SUBJECT: UNIVERSITY OF ILLINOIS AT URBANA-CHAMPAIGN—AMENDMENT RE:
ADMINISTRATIVE REQUIREMENTS (TAC NO. MC4293)

Amendment No. 14
License No. R-115

SAFETY EVALUATION BY THE OFFICE OF NUCLEAR REACTOR REGULATION

CHART I: Administrative organization of the reactor facility. Dashed lines indicate reporting paths outside the operational chain of supervision, indicated by solid lines.

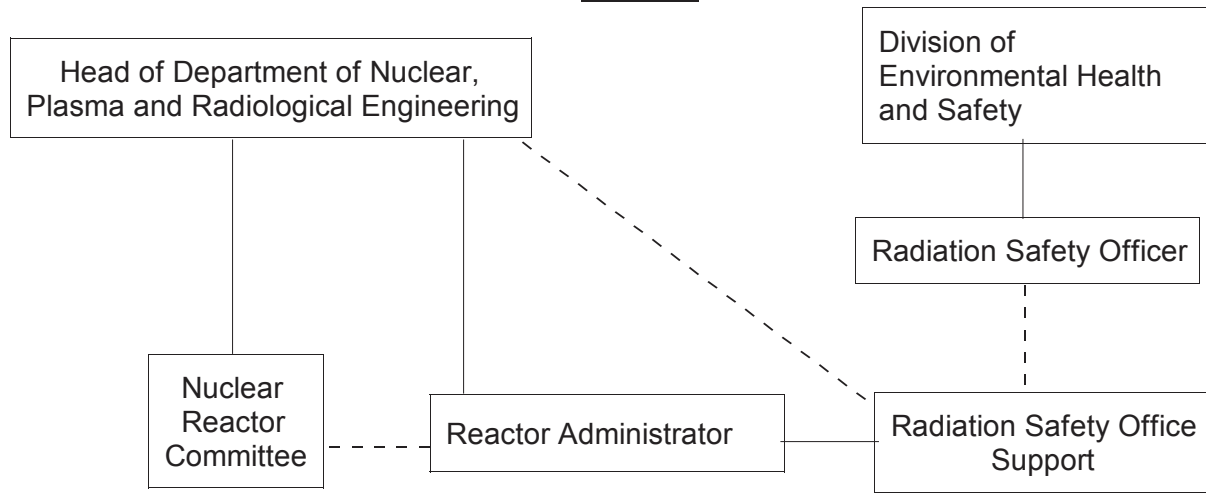
The licensee has requested a change to Chart 1 of the TSs. The chart shows the administrative organization of the reactor facility. The requested change would replace the organizational position of Reactor Health Physicist with Radiation Safety Office Support to reflect the removal of the position of Reactor Health Physicist from the TSs. The staff finds this change acceptable because it is related to the removal of the position of Reactor Health Physicist from the TSs, which the staff finds acceptable as discussed above.
